Statement of Basis

RADIOACTIVE MATERIAL LICENSE (RML) NO. UT 1900479 GROUND WATER QUALITY DISCHARGE PERMIT (Permit) NO. UGW370004

SUMMARY OF CHANGES

January, 2018

Figure 1

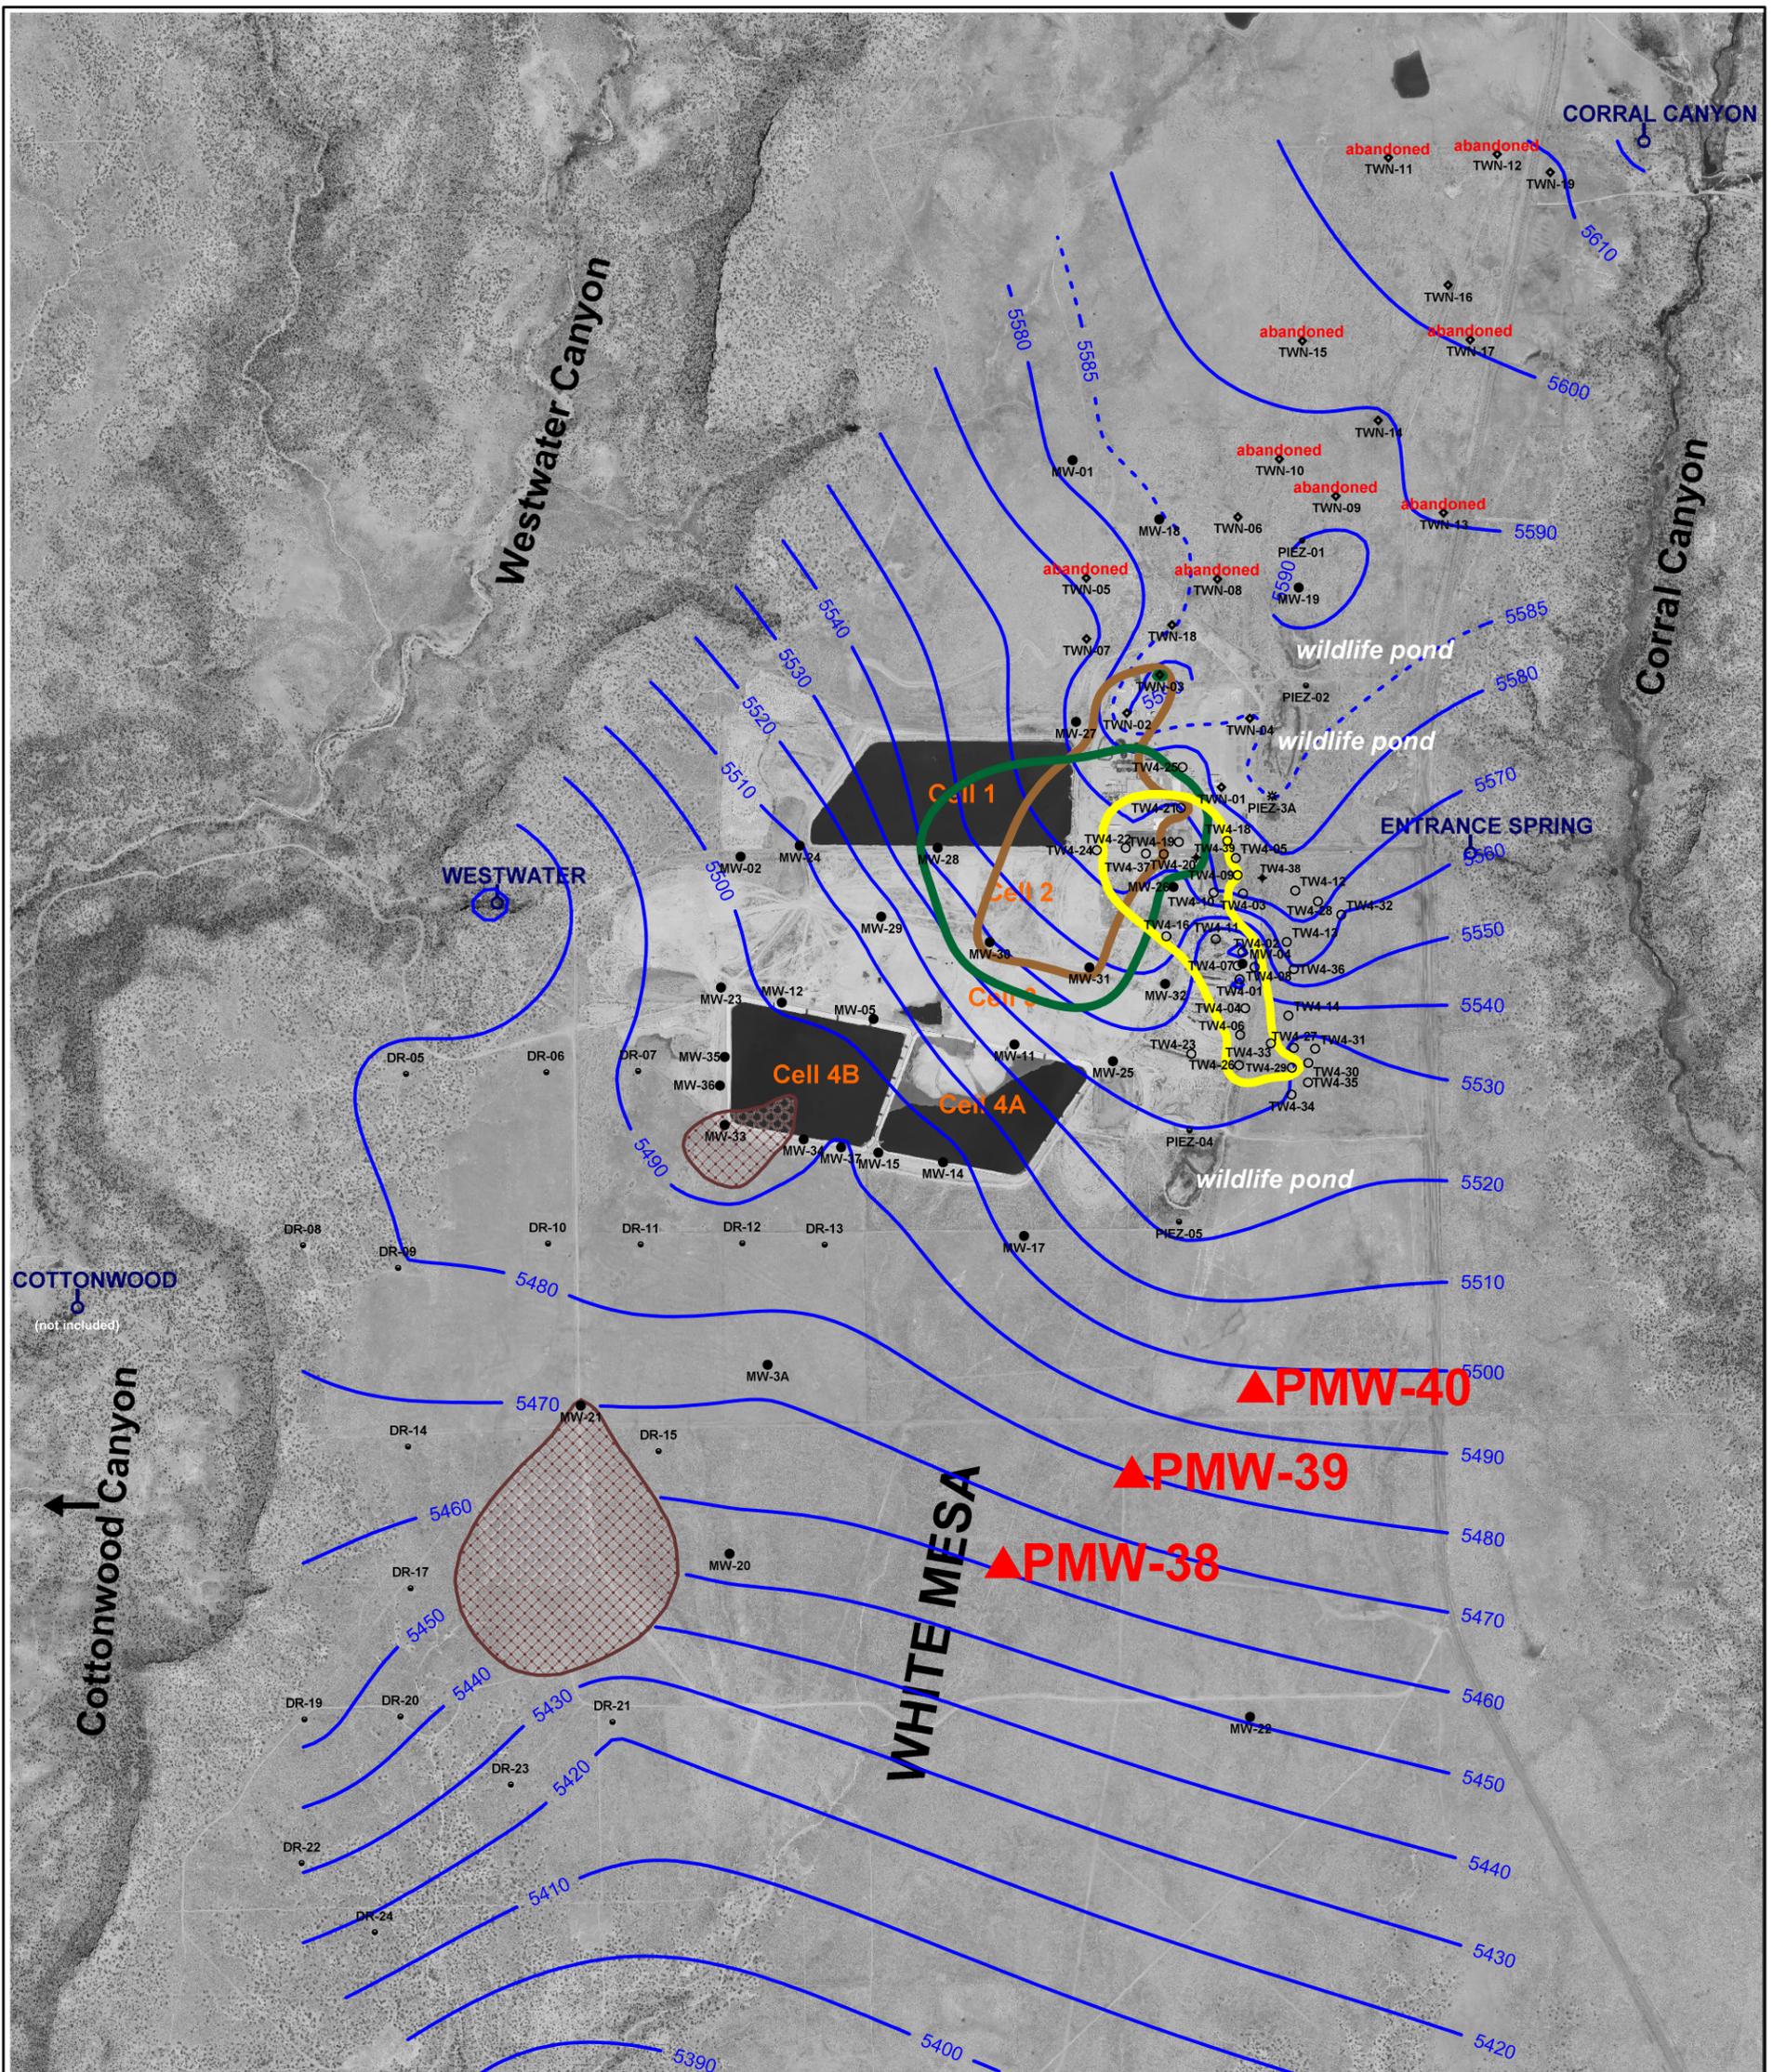
Installation of New Monitoring Wells Part I.H.2

Based on comments received during the public comment period for the Permit, the Permittee has agreed to address a concern from the Ute Mountain Ute Tribe and voluntarily install three monitoring wells in the area in the southeast portion of the Mill Site. The installation of these monitoring wells has been included in Part I.H.2 of the Permit. The requirement includes that the three new monitoring wells, designated MW-38, MW-39, and MW-40, will be located in the area between current monitoring wells MW-17 and MW-22 according to specific locations included in Figure 1 attached to this January 2018 Statement of Basis for the License/Permit Public Participation Summary. The monitoring wells are to be installed 90 calendar days of the issuance of the Permit. The monitoring wells will be drilled and constructed according to Permit requirements and will be completed and an As-built Report is required to be submitted to the Director on or before August 31, 2018.

Part I.H.3 the Permit was added to require that after eight consecutive quarters of groundwater sampling and analysis of new wells MW-38, MW-39, and MW-40 the Permittee will submit for Director approval a Background Groundwater Quality Report.
